SAN GORGONIO CHAPTER

Moreno Valley/Box Springs Group

RE: Item 4.1-4: RIV090903 - Cajalco Road Widening and Safety Enhancement Project – SCH #2011091015;

Figure 1. Future project locations from RCTC Long-Range Transportation Study (2019). The alignment of the Cajalco Road project is the location of the CETAP state highway ID: 3C01MA01 – project 1 in Appendix A.

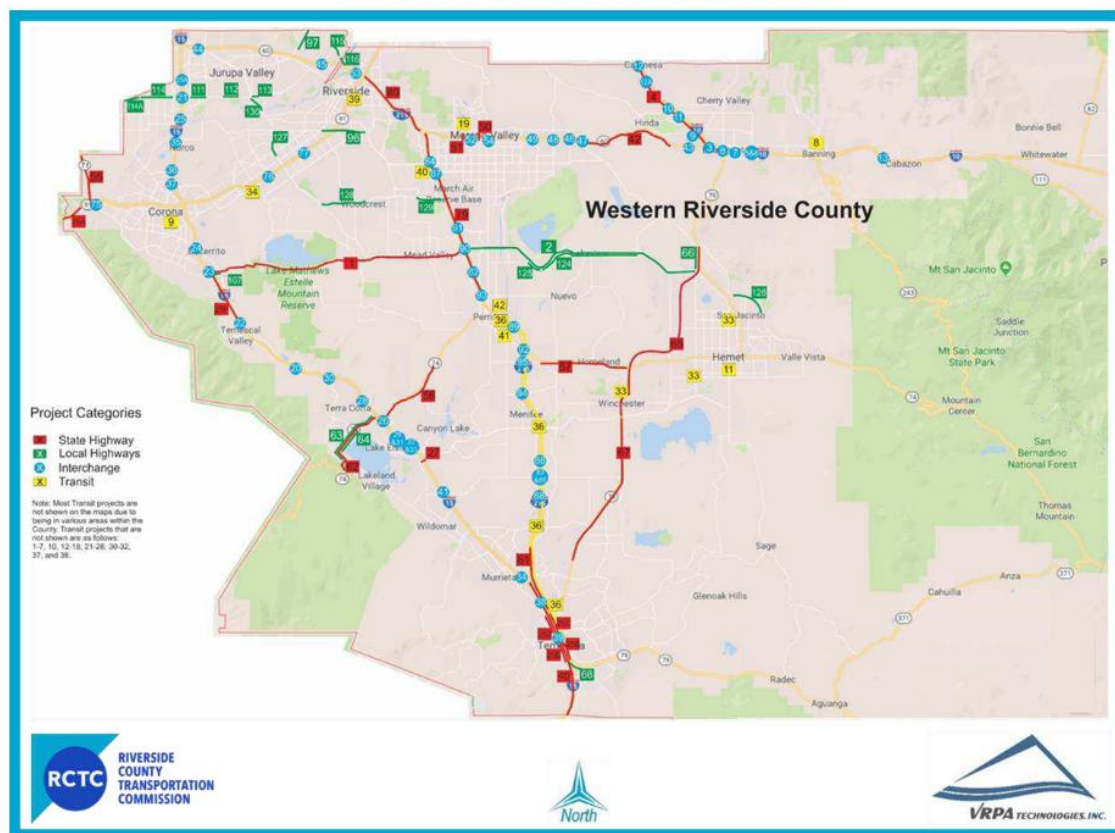
Figure 1 (red line – project 1) shows the alignment of the CETAP east-west highway from the RCTC 2019 Long Range Transportation Study. The CETAP alignment is identical to the proposed Alternative 1 from the Cajalco road widening project; it is NOT a separate parallel facility. It is the long-term 6-lane state highway version of the current proposed 4-lane project. There are no other long-term projects shown in the long-term strategic plan that are a separate parallel facility.

The traffic analysis for the project DEIR and the conformity analysis is **double-counting** the Cajalco road widening and CETAP facility as separate projects and is therefore underestimating future traffic volumes. Please redo all the traffic analysis for this project that double counts traffic volumes using inaccurate RIVCOM model inputs. All traffic analysis that includes the ‘CETAP corridor analysis’ is invalid. Only the ‘Without CETAP corridor’ analysis is possible, with the corresponding higher traffic volumes as shown in **Table 3.6-16** from the DEIR; these traffic volumes are and Level-of-Service ratings are higher and more congested than those identified in Table 2 in the TCWG Project summary. Truck volumes will increase by between 80-350% along the new route with thousands of extra truck trips daily.

Figure 3. Warehouse projects and industrial rezones within a few miles of the terminus of the Cajalco project. Data on Foundation General Plan Amendments from Planning Department.⁶

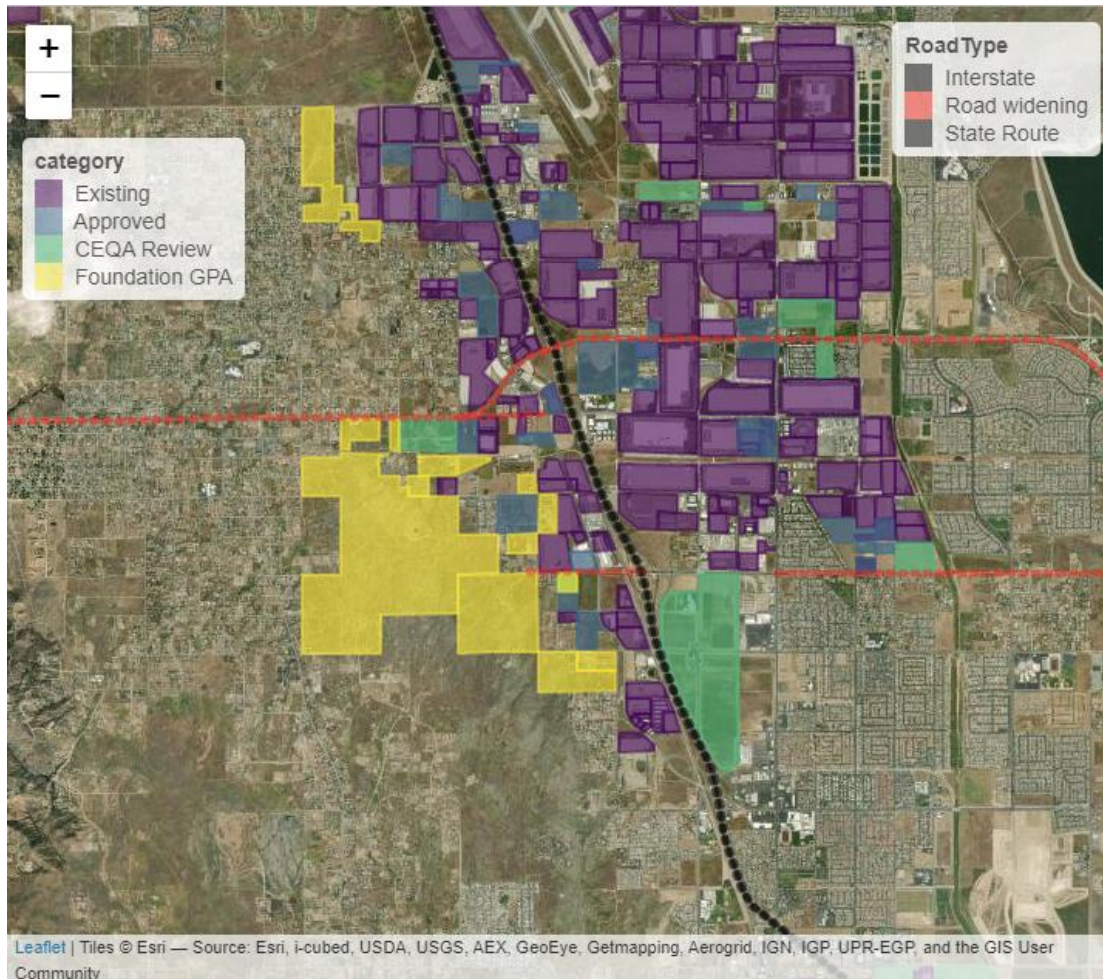
- 1) Warehouse growth on the eastern terminus of the project has more than doubled the footprint of warehouses within 3 miles of the Cajalco-215 on-ramp from ~36M SQ FT in 2014 to over 79M SQ FT in 2025⁴. This has more than doubled truck volumes on I-215.
- 2) Significant additional warehouse growth is planned on the eastern terminus of the project, at least partially because of the long-planned Cajalco roadway expansion. **Figure 3** shows existing, approved, under CEQA review, and under County pre-review projects along the Cajalco – I-215 terminus. Thousands of acres of land are being rezoned from residential to industrial along this roadway and the adjacent Mid County Parkway. A reasonable list of projects to include that are ‘cumulatively considerable’ and ‘reasonably foreseeable’ within 2 miles of the project include:
 - a. Harvest Landing (SCH# 2024080337) – 288 acres of warehouses

In total, the failure to account for land-use changes over the last 10 years and the ongoing rezoning of land-use along this corridor, along with the underestimated truck volumes on major endpoints is resulting in complete failure to accurately project truck volumes.
